EDWIN I. HATCH NUCLEAR PLANT, UNIT NO. 1

AMENDMENT TO FACILITY OPERATING LICENSE

Amendment No. 86
License No. DPR-57

ATTACHMENT TO LICENSE AMENDMENT NO. 86

Figure 3.11.4

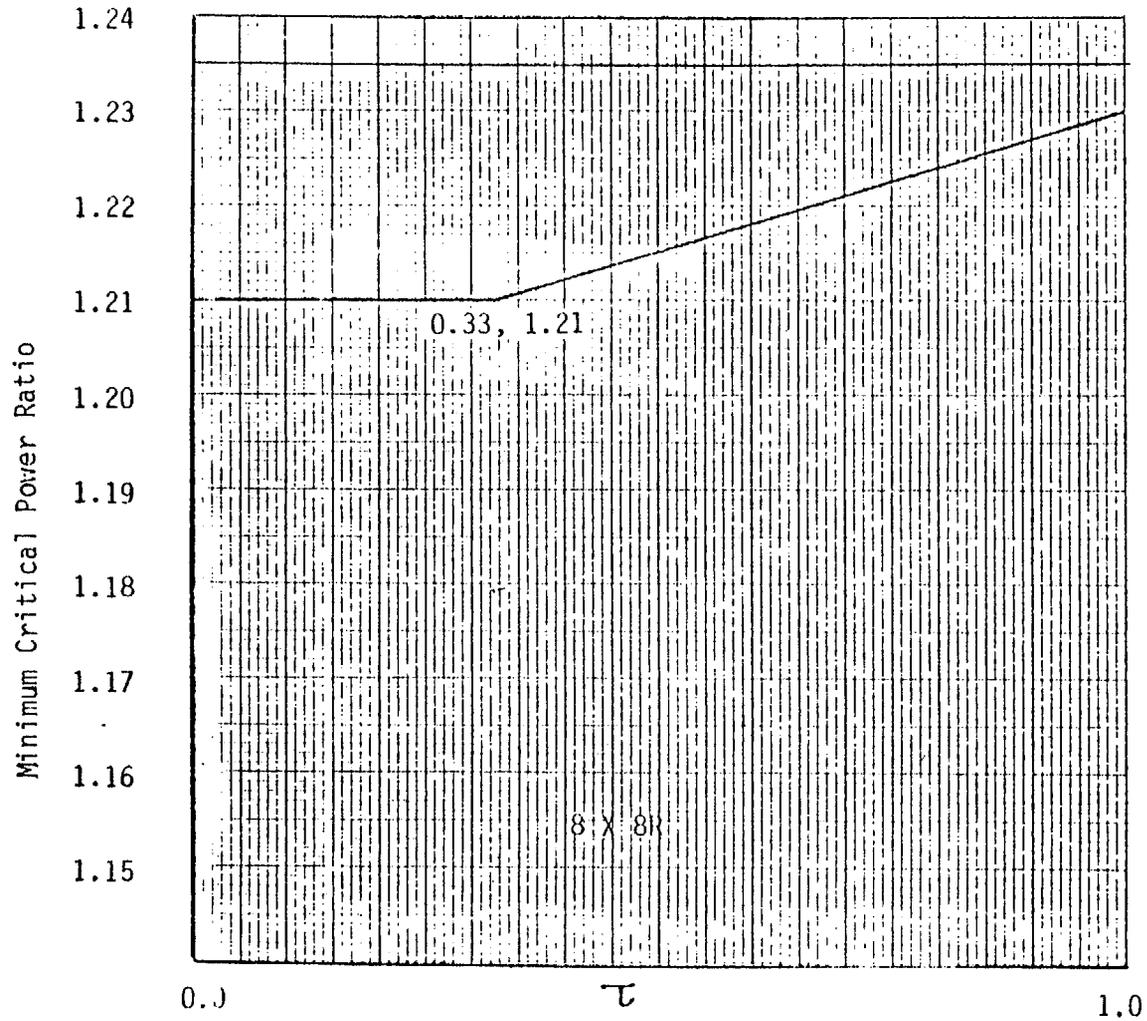
The minimum critical power ratio (MCPR) as a function of scram time and core flow, shall be equal to or greater than shown in Figures 3.11.4, 3.11.5, or 3.11.6 multiplied by the K_f shown in Figure 3.11.3, where:

The MCPR limit at rated flow shall be determined for each fuel type, 8X8R, P8X8R, 7X7 from figures 3.11.4, 3.11.5, and 3.11.6 respectively using:
